GEORGIA DEPARTMENT OF TRANSPORTATION

SR 49 South of CS 629 to SR 7 from SR 49 to South of CS 740

PESTP-0003-00(623) – P.I. No. 0003623

VALUE ENGINEERING REPORT

DESCRIPTION: Reduce the length of the jack and bore section in drainage structures B-59 to B-60

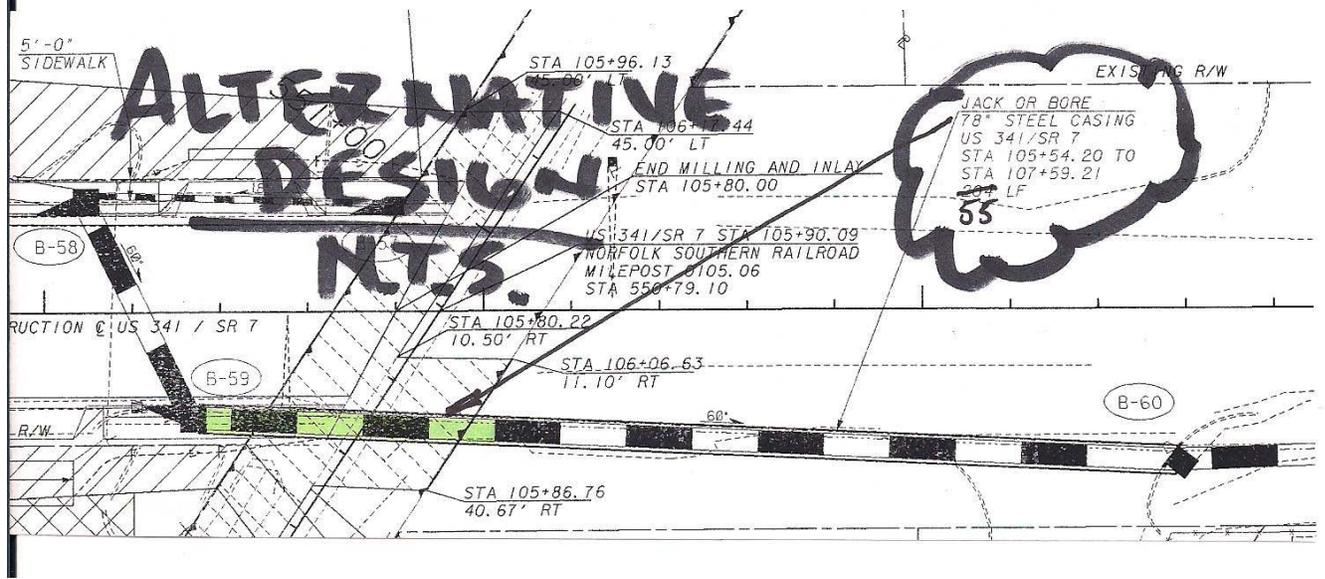
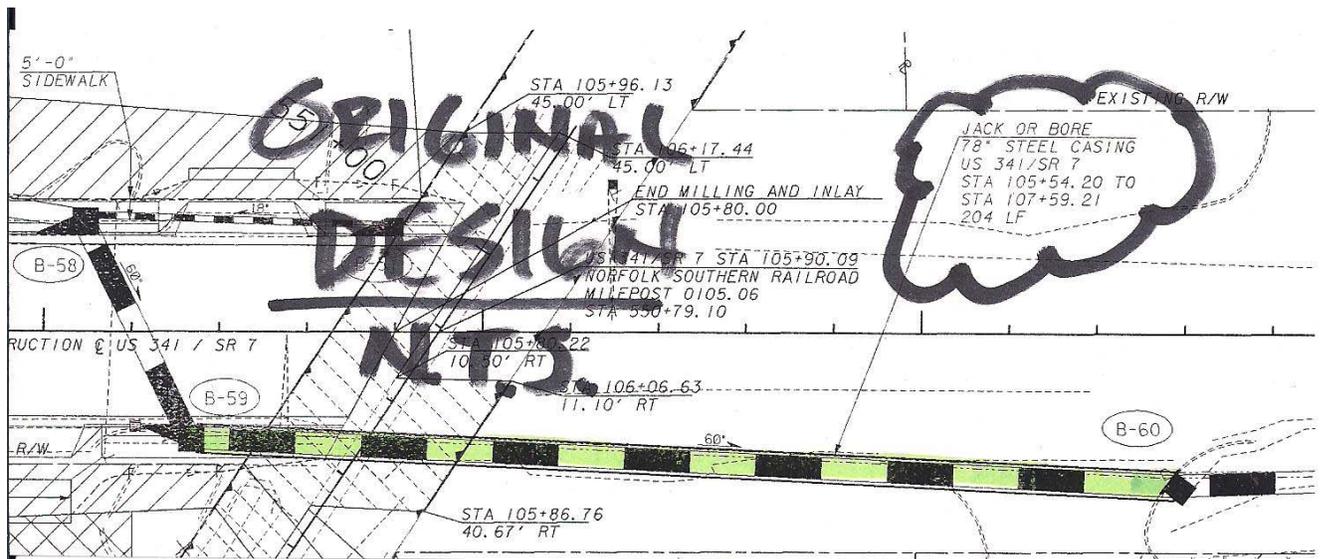
The original design proposes a jack and bore run of 204 LF of 78” steel casing with a 60” RCP transfer pipe.

The alternative proposes to reduce the length of the jack and bore casing to 55 LF.

It appears that the proposed length of steel casing may not be functionally required.

DESCRIPTION: Re-route C1 to C8 thru B-33

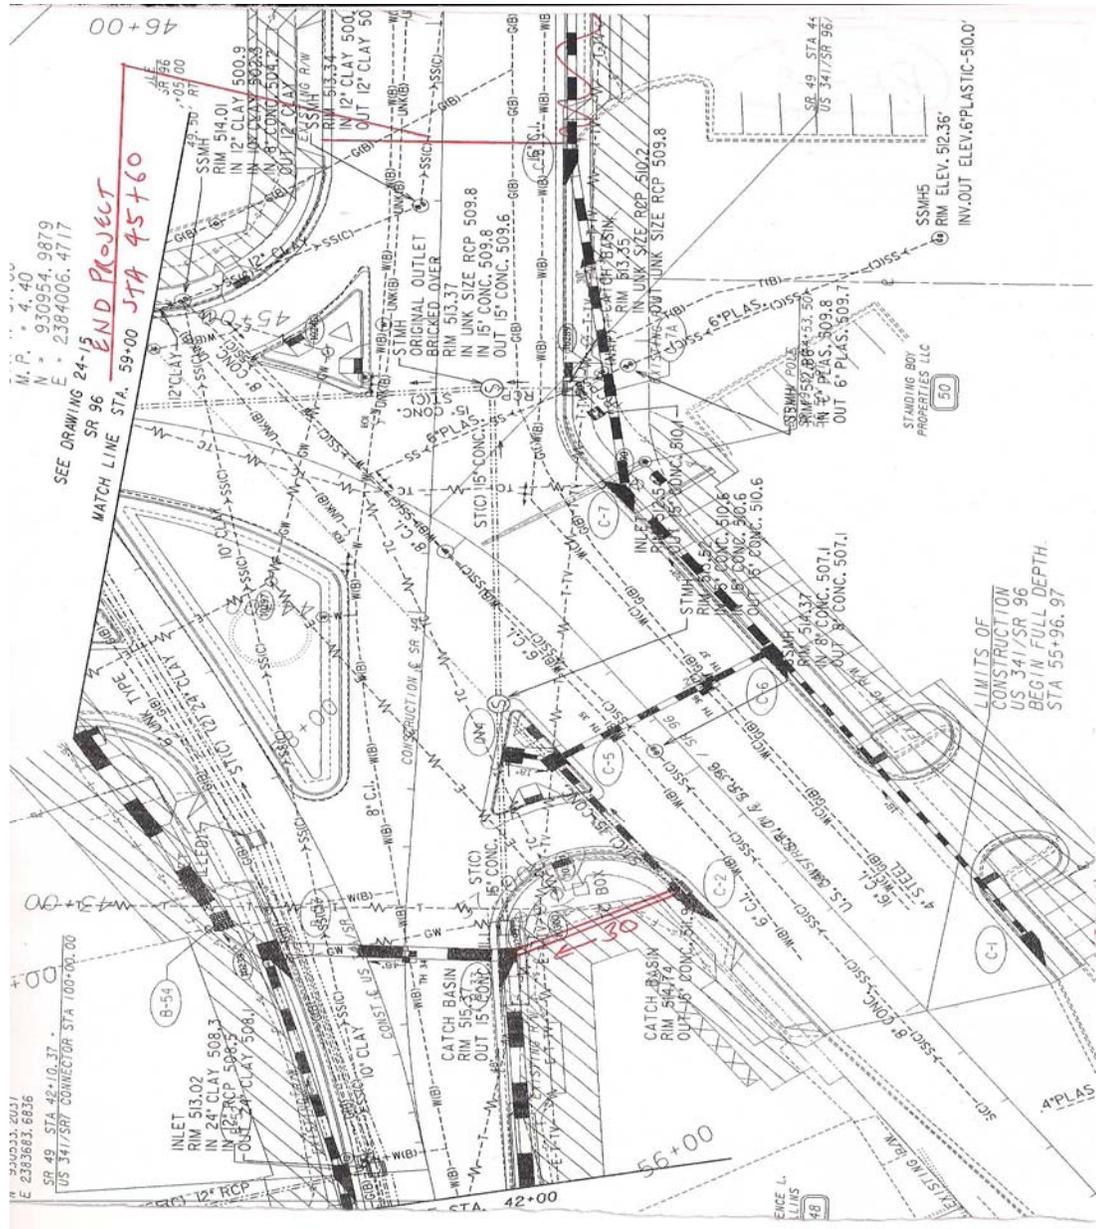
Original Design:
 The original design proposes to discharge Basin 3 runoff to the Railroad side ditch

Alternative:
 The alternative proposes to reroute system C-1 to C-8 into the System B outfall, ending the project at Sta. 45+60, eliminating all impacts at the Railroad

Technical Discussion:
 As presently designed, discharging all of Basin 3 runoff into the Railroad side ditch is a change to the existing drainage pattern. Accommodating this additional runoff will also require improvements to the Railroad side ditch. The proposed design will more closely match the existing drainage pattern. Additionally, since no drainage improvements are needed beyond Sta. 45+60, all roadway improvements beyond that point can be eliminated, resulting in substantial savings.

DESCRIPTION: Place proposed drainage structures in same location of existing storm drain to minimize impacts to utilities.

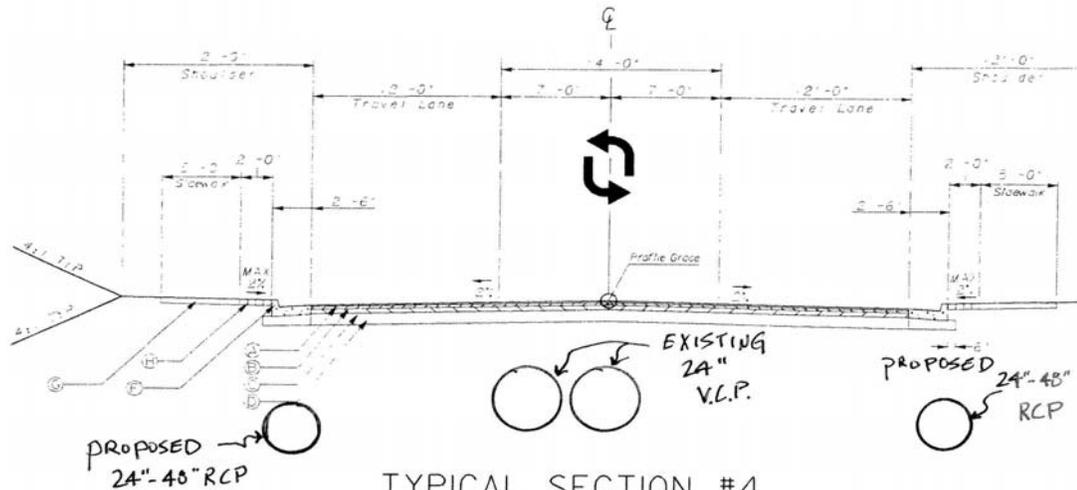
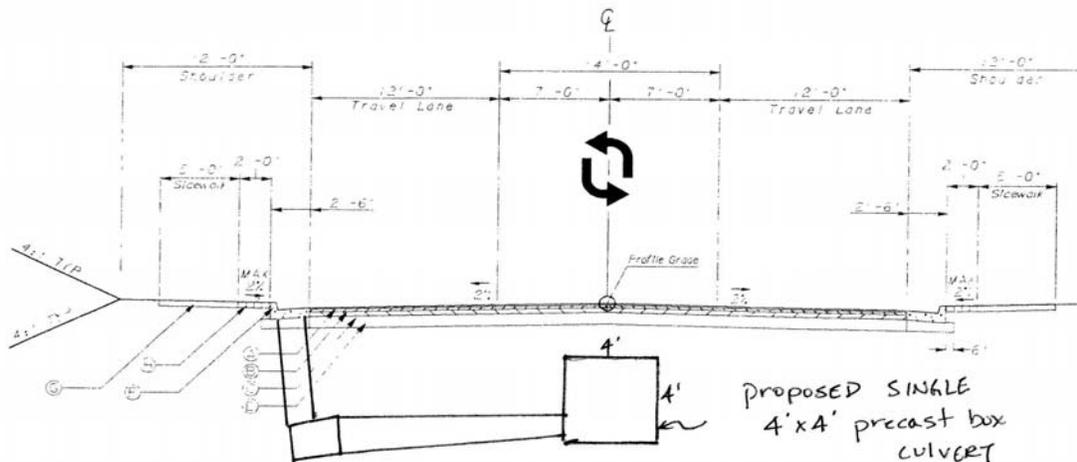
PROJECT:	Georgia Department of Transportation PESTP-0003-00(623) – PI No: 0003623 SR49 South of CS 629 to SR7 from SR 49 to South of CS 740 Peach County	ALTERNATIVE NO.: DR-10																
DESCRIPTION:	Place proposed drainage structures in same location of existing storm drain to minimize impacts to utilities.	SHEET NO.: 1 of 4																
<p>Original Design:</p> <p>The original design proposes a dual system for storm drainage located on the east and west sides of the roadway using RCP from Approximate STA 25+00 to approximate STA 47+00.</p> <p>Alternative:</p> <p>The alternative proposes constructing a single 4'x 4' precast culvert in lieu of the proposed double RCP run from approximate STA 25+00 to approximate STA 47+00.</p> <table style="width: 100%; border: none;"> <tr> <td style="width: 50%; vertical-align: top;"> <p>Opportunities:</p> <ul style="list-style-type: none"> • Reduction in utility conflicts • Greater hydraulic capacity • Removal of existing VCP, eliminating future void problems </td> <td style="width: 50%; vertical-align: top;"> <p>Risks:</p> <ul style="list-style-type: none"> • None apparent </td> </tr> </table> <p>Technical Discussion:</p> <p>The alternative proposes constructing a single precast 4'x4' culvert from approximate STA 25+00 to approximate STA 47+00 in the same location as the existing dual 24" VCP. Substituting the single precast for the dual pipe system offers several advantages. First, it reduces the initial cost by substituting a single precast run in lieu of a dual system contemplated with various sizes of RCP. Secondly, by placing the precast in the same location as the existing VCP will require removal of the existing pipe, eliminating substantial flowable fill costs as well as eliminating the possibility of future voids that may occur by leaving the VCP in situ. Lastly, a single system will allow for fewer disruption during construction phasing by allowing the drainage to be installed in one open cut as opposed to two open cuts required by construction of a dual system.</p>			<p>Opportunities:</p> <ul style="list-style-type: none"> • Reduction in utility conflicts • Greater hydraulic capacity • Removal of existing VCP, eliminating future void problems 	<p>Risks:</p> <ul style="list-style-type: none"> • None apparent

DESCRIPTION: Use two jack and bore sections in lieu of one from
 drainage structures A-41 to A-55

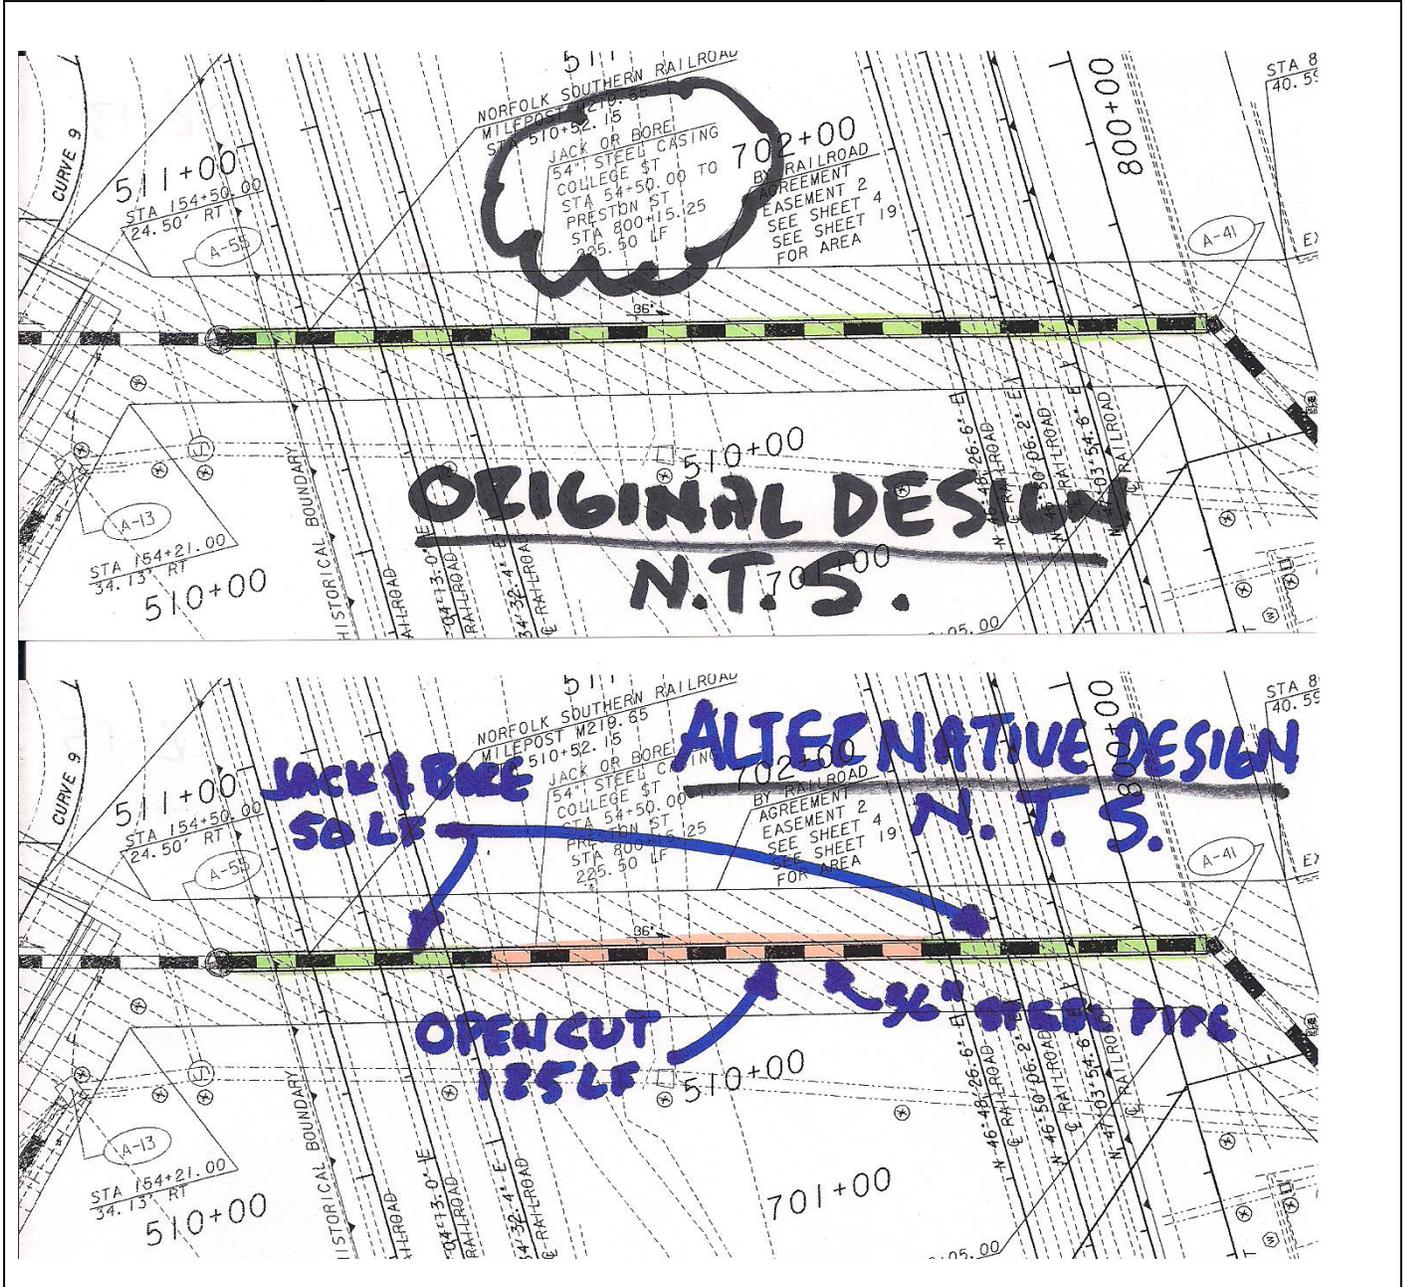
The original design proposes to jack and bore a single run of 225 LF of 54” steel casing with a 36” RCP transfer pipe.

The alternative proposes to jack and bore two sections of 36” heavy wall steel pipe and open cut to weld in the center section.

A jack and bore length of 225’ will prove to be much more difficult than two 50’ sections with installation by means of open cut for the center section.

DESCRIPTION: Eliminate Piping in Selected Areas - Site #1

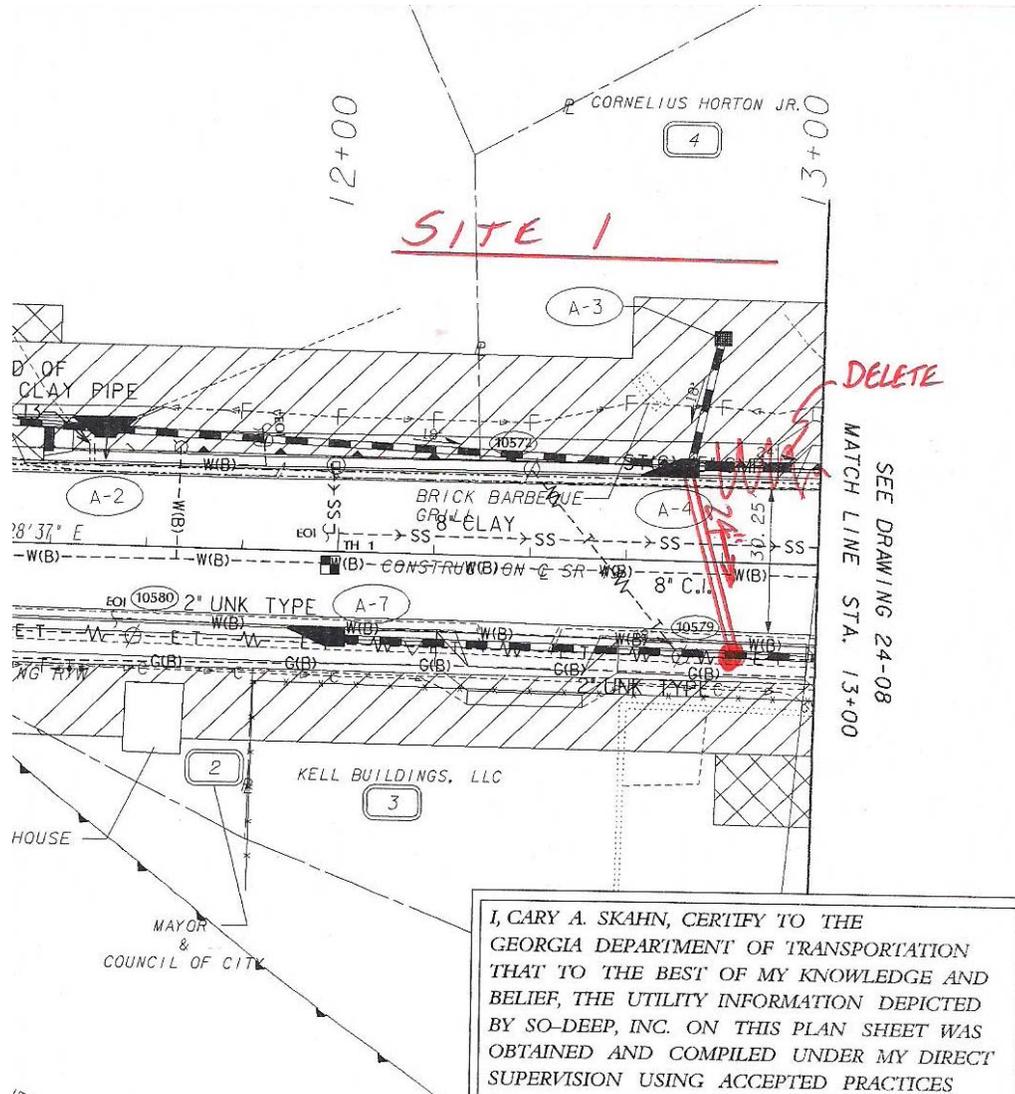
<p>PROJECT: Georgia Department of Transportation PESTP-0003-00(623) – PI No: 0003623 SR49 South of CS 629 to SR7 from SR 49 to South of CS 740 Peach County</p>	<p>ALTERNATIVE NO.: DR-14</p>		
<p>DESCRIPTION: Eliminate Piping in Selected Areas</p>	<p>SHEET NO.: 1 of 9</p>		
<p>Original Design: The original design proposes drainage layout as shown in Illustrations 1 thru 6</p> <p>Alternative: The alternative proposes various realignments</p> <div style="display: flex; justify-content: space-between;"> <div style="width: 45%;"> <p>Opportunities:</p> <ul style="list-style-type: none"> • Reduction in lengths of various Storm Drain Pipe • Reduction in drainage related costs </div> <div style="width: 45%;"> <p>Risks:</p> <ul style="list-style-type: none"> • Requires additional Hydraulic Calculations • Requires additional open-cuts across the Roadway </div> </div> <p>Technical Discussion:</p> <p>Due to utility conflicts, a dual storm system (along each edge of roadway) is required. In a few locations, those utility conflicts a minimal, allowing for a lateral connection across the roadway, rather than a lengthy longitudinal run of pipe. Additionally, some alignment modifications can be made while maintaining the designed site collection points. These revisions result in the reduction of storm drain pipe required. These changes will require additional hydraulic calculations to verify the sizes of the receiving pipes.</p>
